Lucan to City Centre Core Bus Corridor Scheme

NTA Observations on the Proposed Scheme Submissions

May 2023

Figure 2.1.3.5.4 Extract from GDA Cycle Network Plan included as Image 2.1 in Chapter 2 Need for the Proposed Scheme in Volume 2 of the EIA with suggested alternative cycle route shown

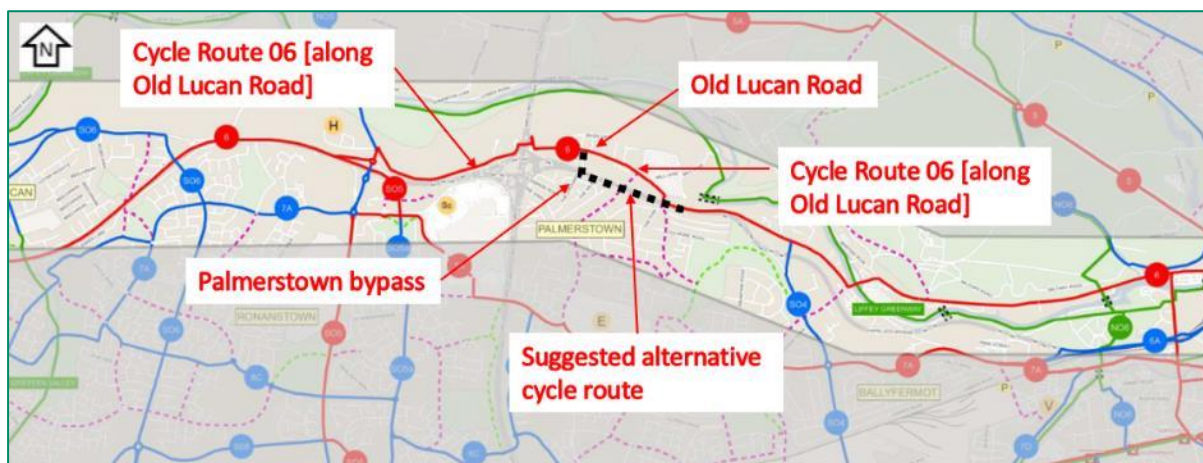
The submissions propose an alternative route for the Primary Cycle Route diverting off the Old Lucan Road at the old Fassenbridge Garage site (opposite the Old Beehive) and into the SHD development. However, it is unclear where the route should continue to after exiting the SHD, although it would be reasonable to assume it would continue along the Palmerstown bypass to connect with the shared area past the Applegreen petrol station at The Oval Junction, see Figures 2.1.3.5.3 and 2.1.3.5.4.

Figure 2.1.3.9.5: Extract of General Arrangement Drawings at the Oval Junction (Sheets 15 & 16)

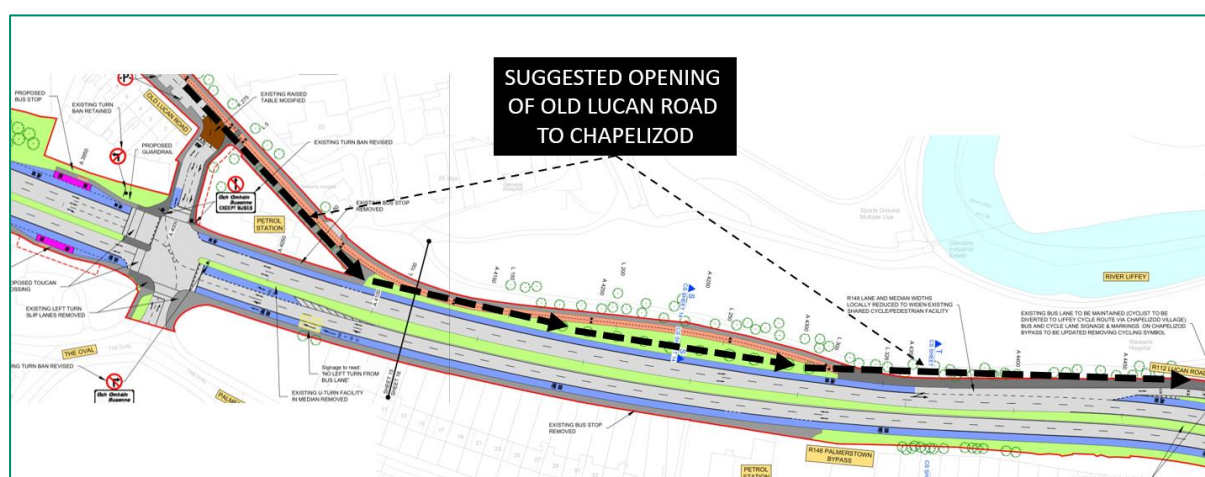
Figure 2.1.3.9.5 shows the suggestion superimposed on the relevant extract of the General Arrangement drawings, immediately to the east of The Oval junction.
